PRELIMINARY PLAT REVIEW PUBLIC HEARING (CONTINUED)

By: Y2 Consultants
For: JC Ranches Subdivision
Where: W 4000 N and N 2000 W, south of Tetonia
Planning and Zoning Commission
Prepared For: Public Hearing on July 9, 2024 & September 10, 2024

APPLICANT & OWNER: JD ID WY LLC (JIM HERBERT)
ENGINEER: Y2 Consulting

Figure 4. Preliminary Plat (Layout from Improvement Plans for context)

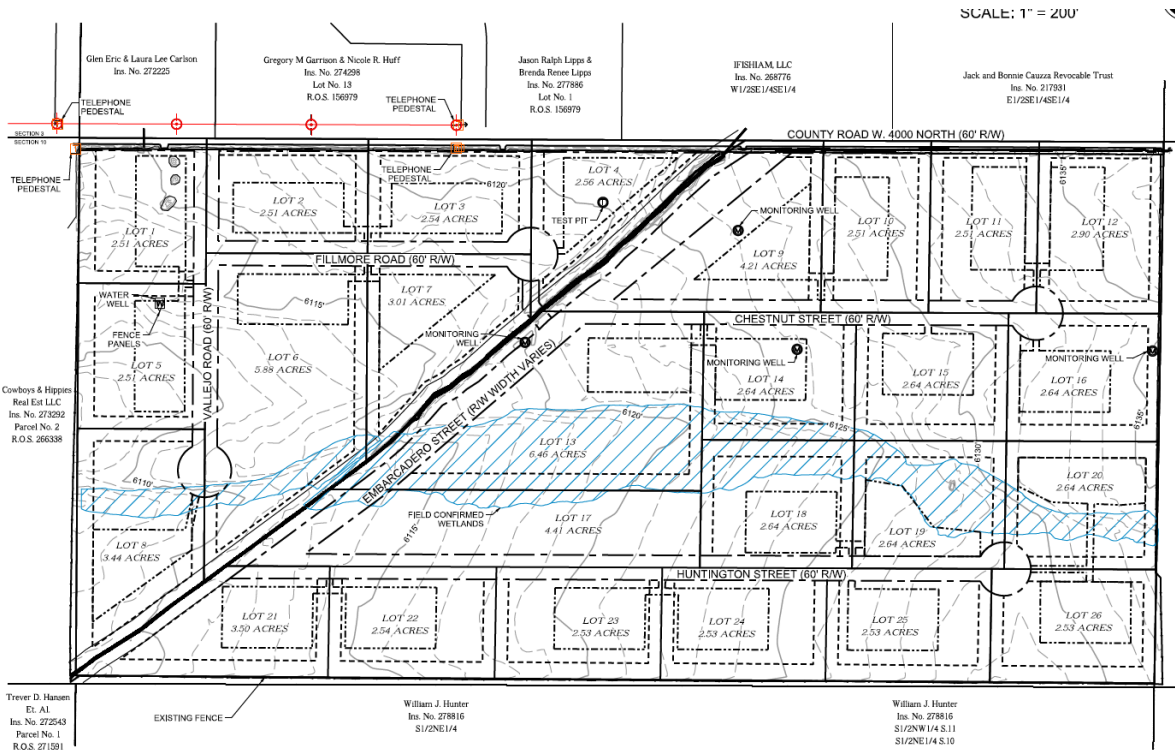
- **ROADS & UTILITIES:** Teton County Public Works Director made the following comments:
 - The preliminary plat does not show entire subdivision boundary.

- Applicant will need to obtain an Access Permit from Road & Bridge prior to final plat application. Minimum 300 feet separation between access points is required. Separation requirement applies to access points on both sides of the County Road. Applicant is encouraged to consider aligning an access with Los Pinos Drive.

- Second access requirements are intended to provide an alternative egress. The configuration shown provides two access points but is not connected by interior subdivision roads so does not accomplish the intended purpose.

Figure 5. Updated preliminary plat (layout still used from updated improvement plans)

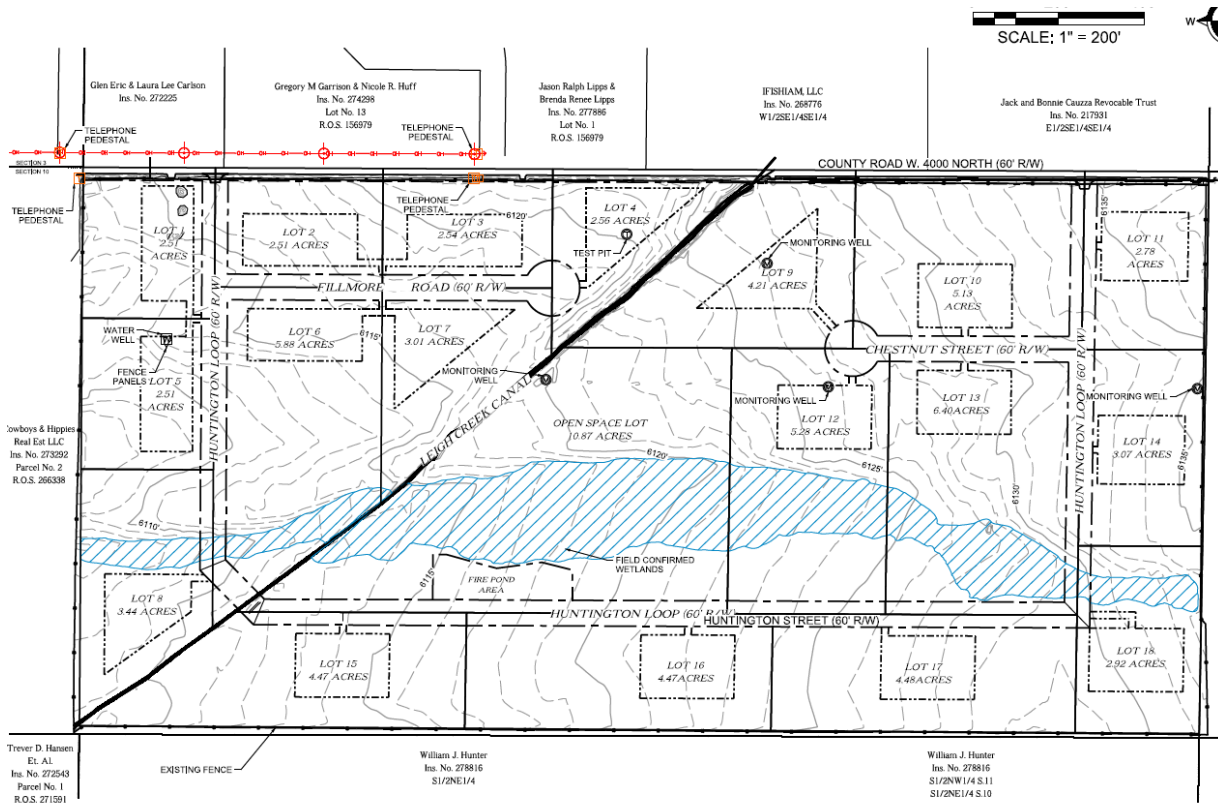
- Public works reviewed the revised materials and had the following comments (9/3/24):
 - Applicant will need to obtain an Access Permit from Road & Bridge prior to final plat. This will allow for R&B review and change if needed. Minimum 300 feet separation between access points is required. Separation requirement applies to access points on both sides of the County road. Applicant is encouraged to consider aligning subdivision access with Los Pinos Drive.

- Minimum cul-de-sac width is 60' radius. It is not clear what radius is shown.
- **FIRE PROTECTION:** The Fire Marshal had the following comments:
 - Is approved for fire department apparatus access and proposed fire pond water source for Fire suppression

- The applicant amended the layout to include only 18 lots which would no longer require the secondary access point. Further, Huntington Loop now connects, providing the secondary access.

- A fire pond is proposed on lot 17. This lot was amended to be a larger, fully open space tract of 10.87 acres.
